**SUPPLEMENTAL  
ENVIRONMENTAL IMPACT REPORT**

**SILVA VALLEY PARKWAY INTERCHANGE PROJECT**

**(SCH NO. 1988050215)**

June 2011

FIGURE 3

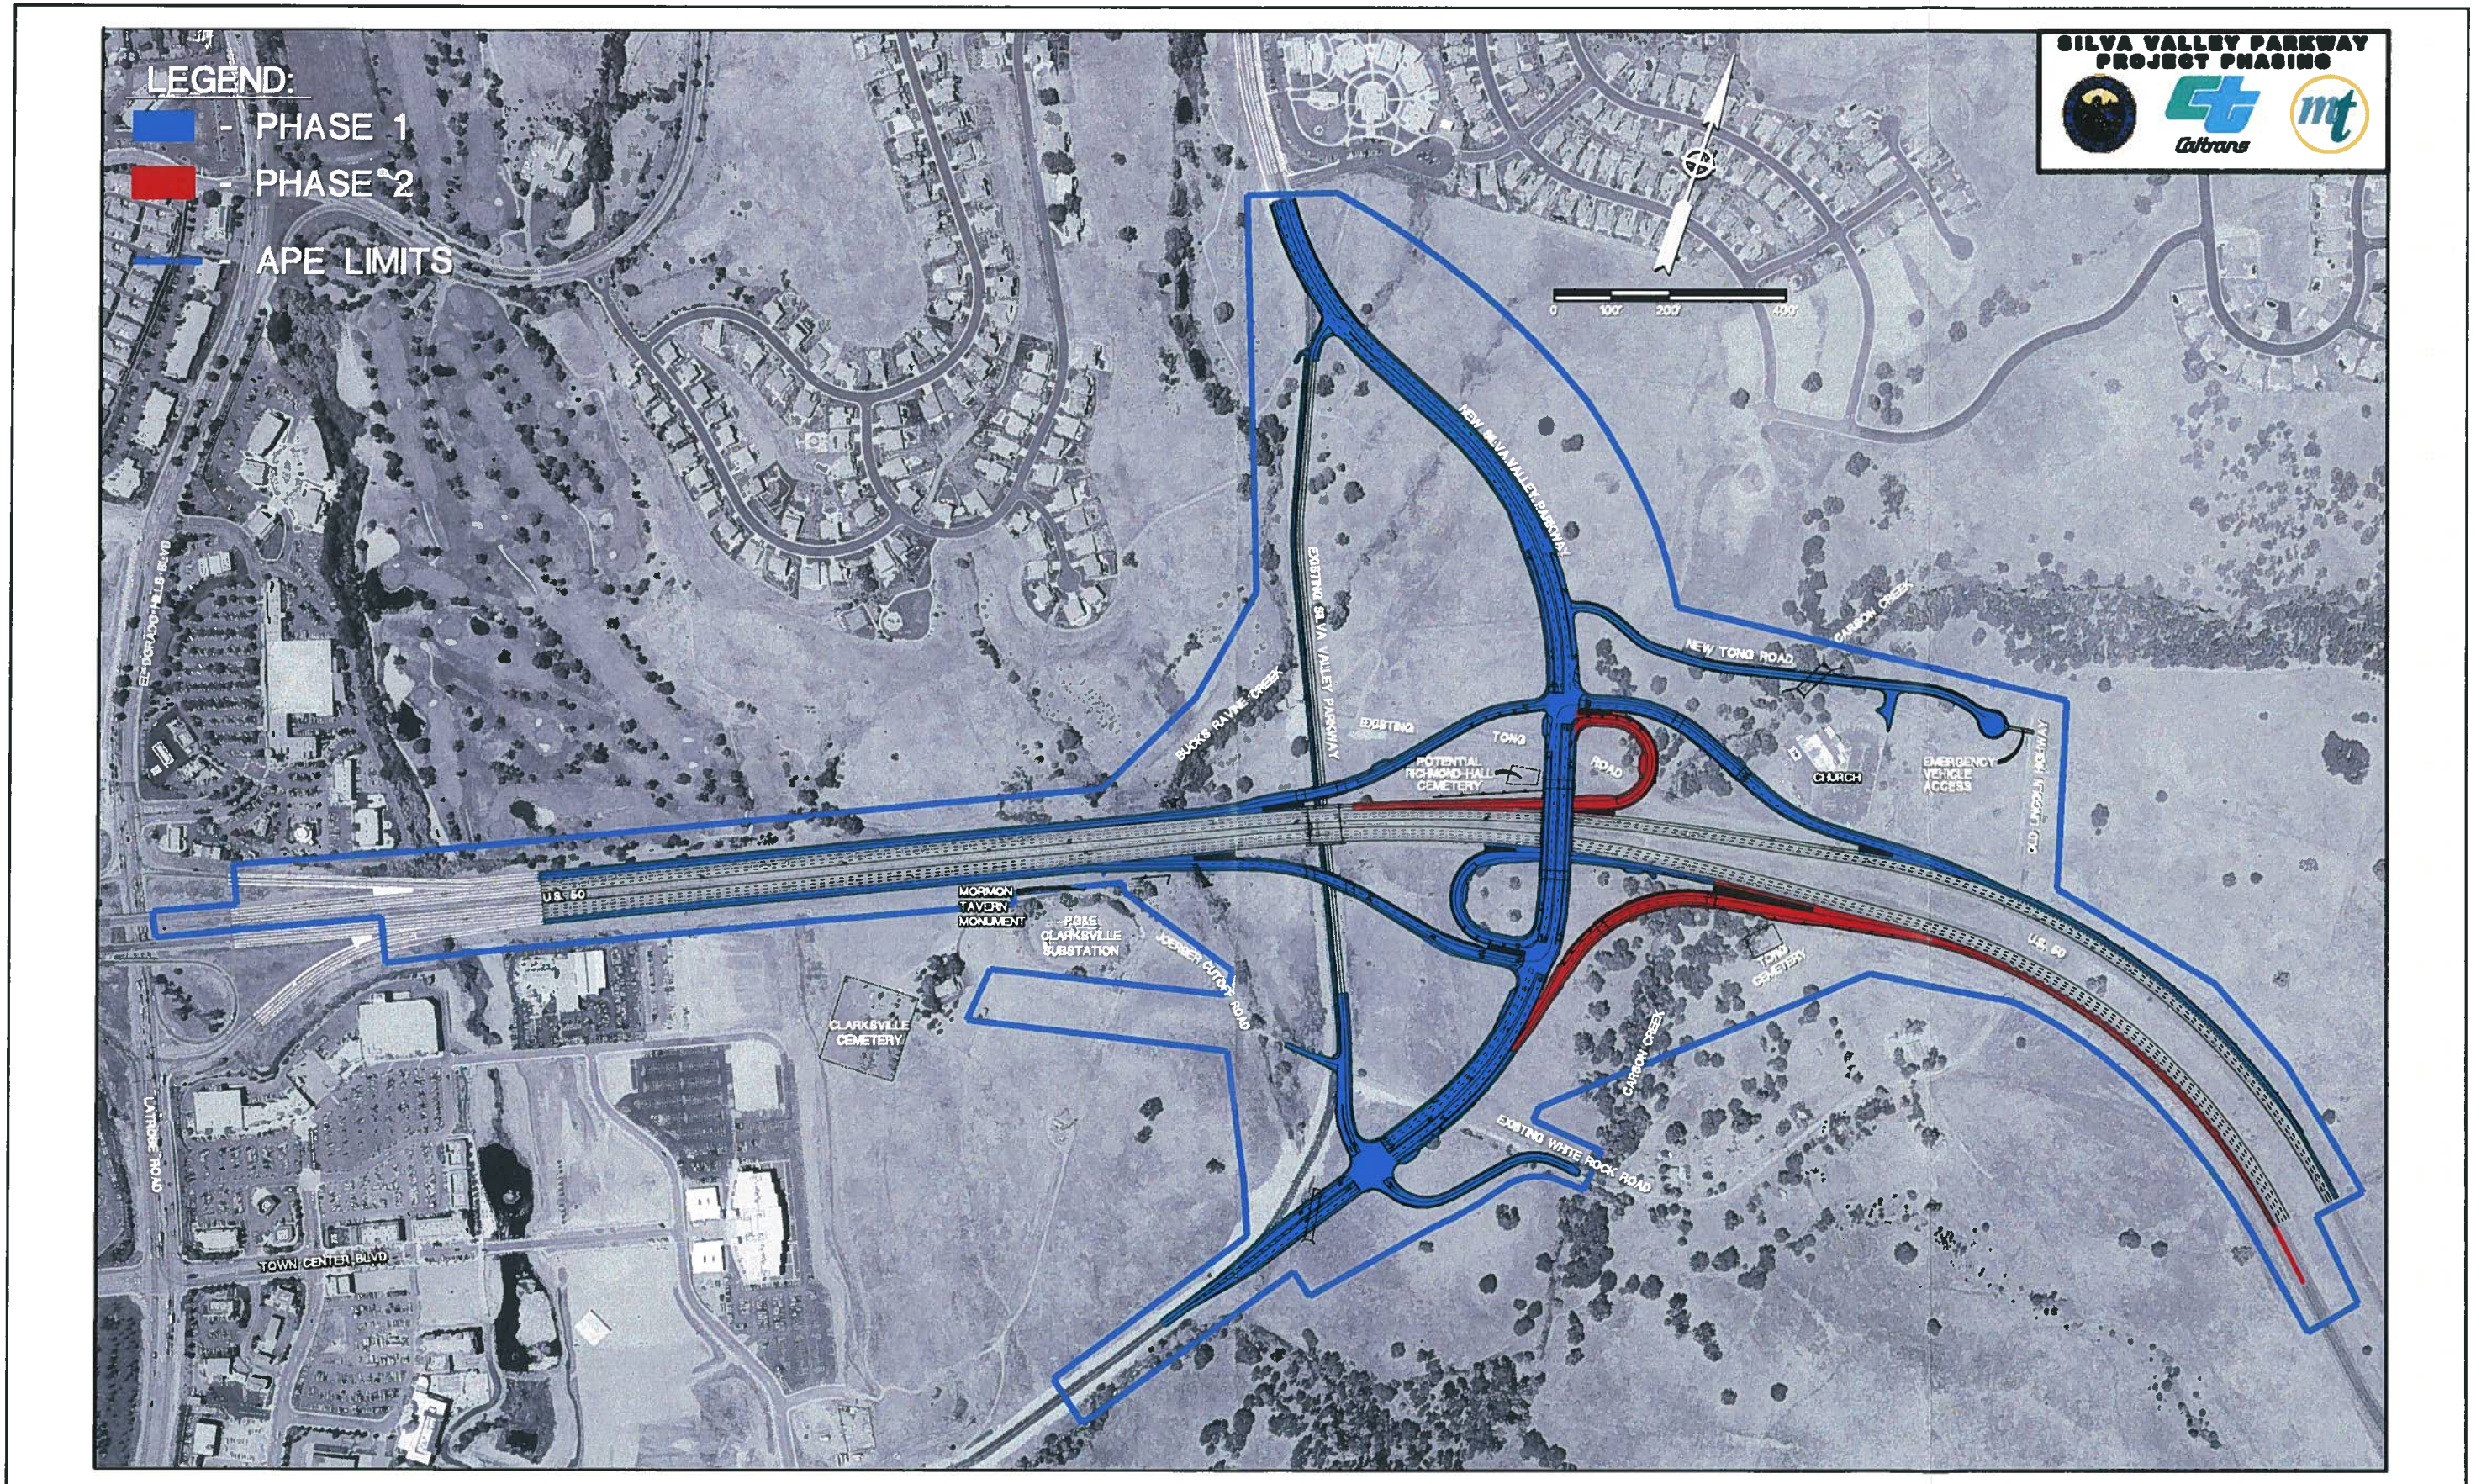
Figure 2 (page 9 of the LSA report), Figure 3 (page 11 of the LSA report) and Figure 1A (page 2 in the Traffic Study) appear to be inconsistent as it relates to Tong Road and Country Club Drive. The text of both reports, which refer to the above figures, also appears to be inconsistent. These inconsistencies make it difficult to understand how interim and permanent access to the parcels in the northeast quadrant of the interchange will be provided. Please clarify.

Also, please clarify the phasing of the improvements. Figure 3 of the LSA Report shows the westbound loop ramp and eastbound direct ramp as the last phase, whereas Figure 1a of the Traffic Study shows both loop ramps as the last phase. Please clarify.

KB-1: The SEIR prepared by LSA is the most recent and therefore most accurate report. Figure 3 of the LSA report gives the most accurate representation for the re-alignment of Tong Road as it relates to the adjacent parcels. All of the parcels, which take access from the existing Tong Road, will continue to receive access. A future separate project is proposed to build Country Club Drive, which will provide access to parcels northeast of the Silva Valley Interchange project.

KB-2: The proposed project was originally planned to be constructed in three phases. The project has since been revised to include only two phases. Therefore Figure 3 of the LSA SEIR represents the most accurate phasing plan for the project.

FIGURE 4

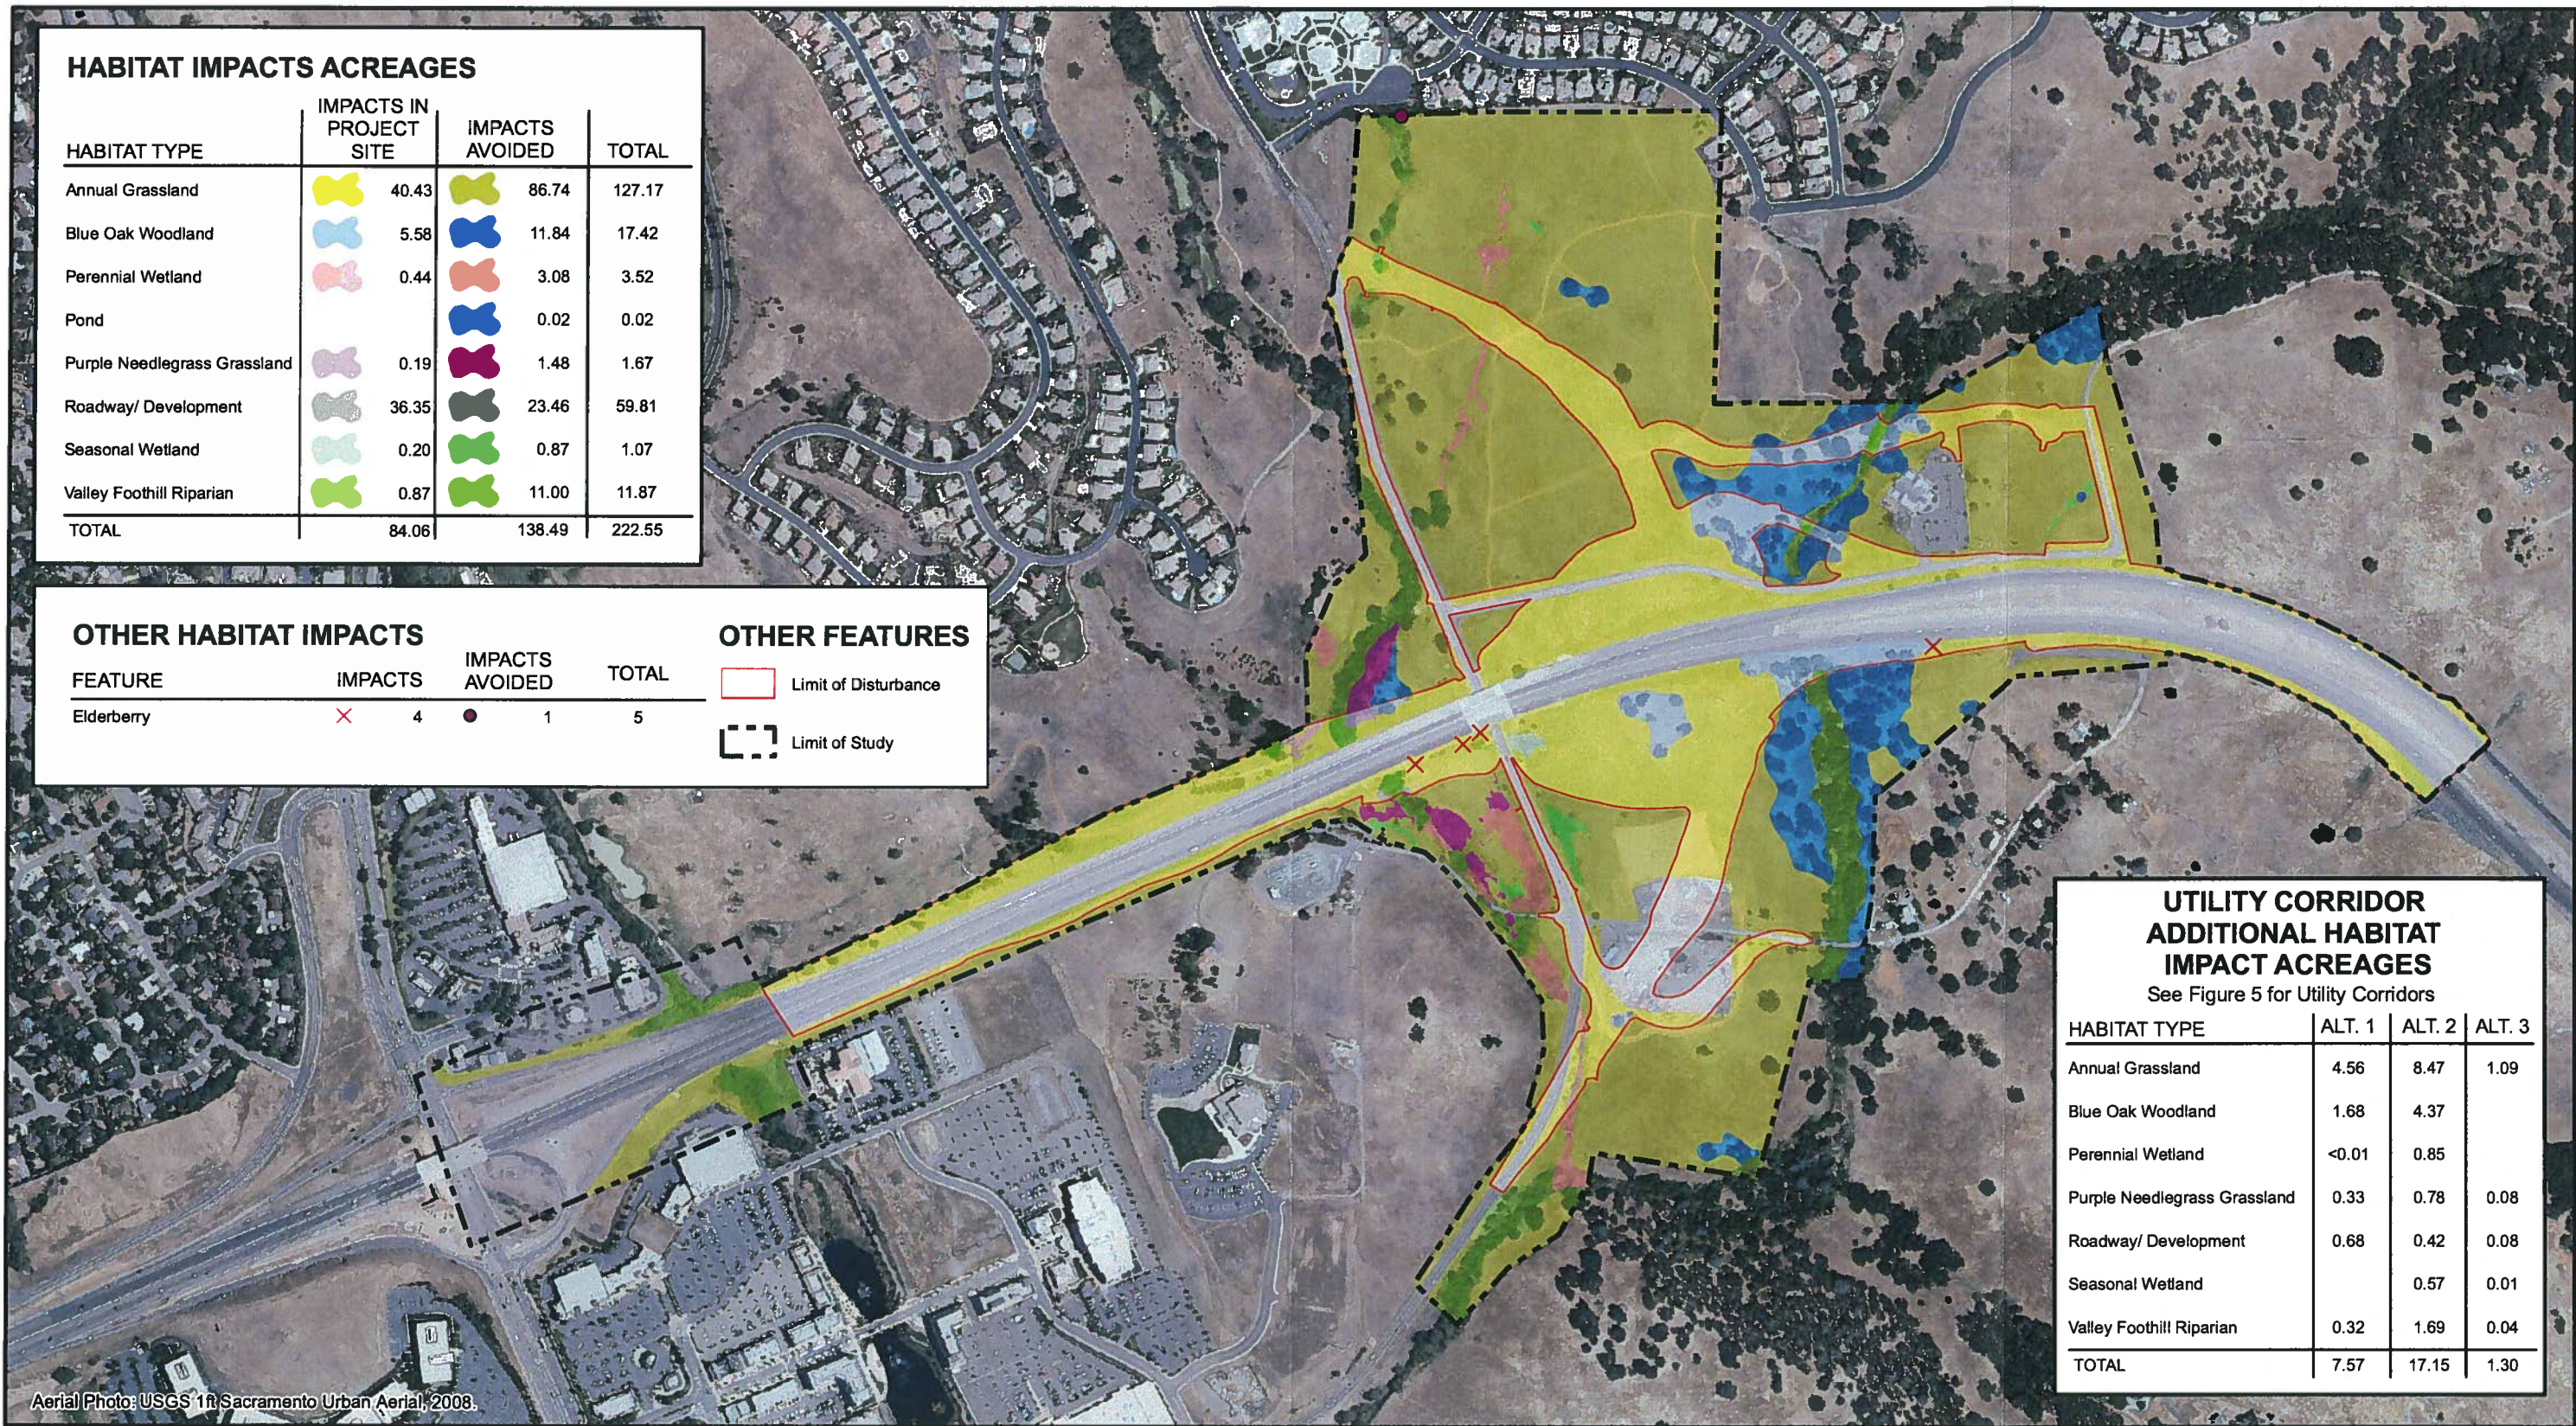
Page 42 – *Figure 4: Utility Corridor Additional Habitat Impact Acreages* identifies the Limit of Disturbance (LOD) for the proposed Project activities. However, the LOD does not include all of the EID utility modifications necessary to meet public service requirements resulting from implementation of the proposed Project. The additional areas that should be included in the LOD are as follows:

Due to the additional areas being impacted by El Dorado Irrigation District utilities, minor changes to biological impacts have occurred (see revised Figure 4). Specifically, these changes include:

EID-3: Figure 4 has been amended to include EID facilities. See Errata section.
